Title - Sujet Snootli Creek Hatchery Aeration Fac	
Solicitation No. - N° de l'invitation F1700-211944/A	Amendment No. - N° modif. 001
Client Reference No. - N° de référence du client F1700-211944	Date 2021-11-25
GETS Reference No. - N° de référence de SEAG PW-\$PWY-031-9077	
File No. - N° de dossier PWY-1-44133 (031)	CCC No./N° CCC - FMS No./N° VME
Solicitation Closes - L'invitation prend fin at - à 02:00 PM Pacific Standard Time PST on - le 2021-12-07 Heure Normale du Pacifique HNP	
F.O.B. - F.A.B.	
Plant-Usine: <input type="checkbox"/> Destination: <input checked="" type="checkbox"/> Other-Autre: <input type="checkbox"/>	
Address Enquiries to: - Adresser toutes questions à: Leung, Janie	Buyer Id - Id de l'acheteur pwy031
Telephone No. - N° de téléphone (778) 919-3273 ()	FAX No. - N° de FAX (604) 775-6633
Destination - of Goods, Services, and Construction: Destination - des biens, services et construction: DFO – Snootli Creek Hatchery – Bella Coola, BC

This Amendment 001 is raised to issue Addendum 001.

ANSWERS TO QUESTIONS RAISED BY BIDDERS

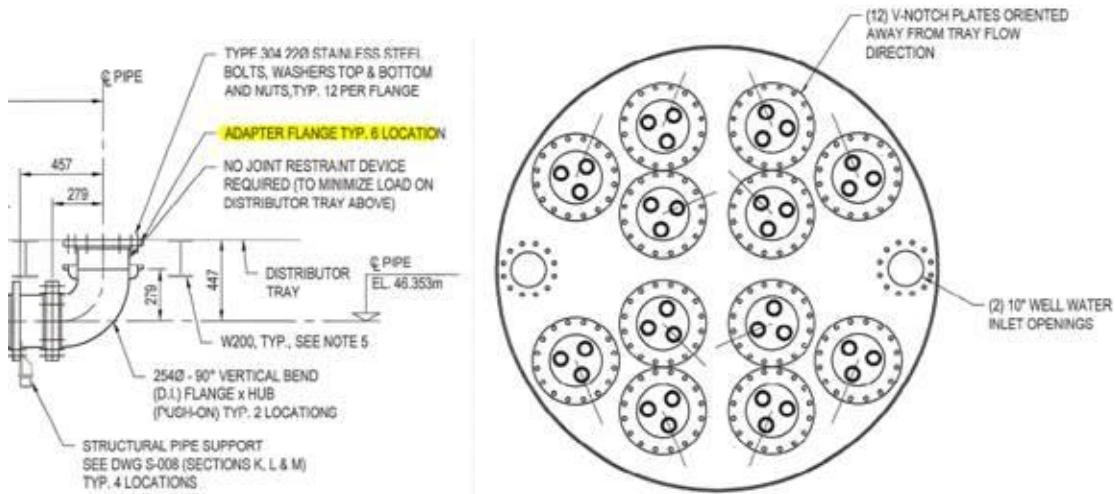
Q1. On drawing C-009 can you please provide a detail of this connection and how it should be assembled as a 1390 is a restraint harness for pipe bell joints and 900 is a flange adaptor:

A1. Do not use a flange adaptor where there is a “push-on”, hub or bell joint. Use flange adaptors to connect to flanged joints. Use joint restraint devices at “hub” or bell connection joints.

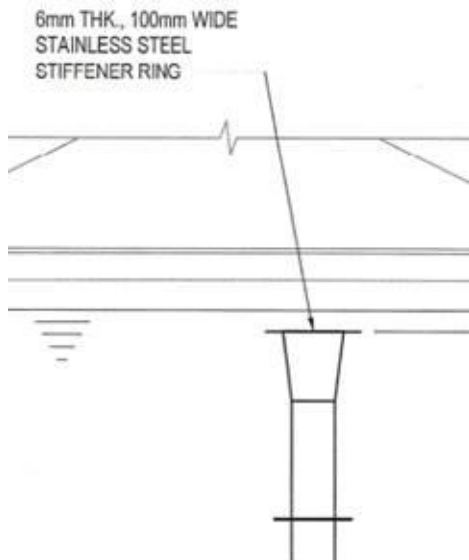
Q2. On drawing C-009 can you please provide a detail to where the 6 locations are? I only see 2 on the drawings.

A2. The are six locations along the top, horizontal run of pipe that turns up to connect to the underside of the distributor tray : one at the underside of distributor tub, one at the flange end of the vertical pipe bend, one at the “inside” structural support (see Dwg -S-008, Sections K, L & M) for the horizontal pipe run, one on each side of the expansion-contraction joint, and one at the “outside” structural support for the horizontal pipe run.
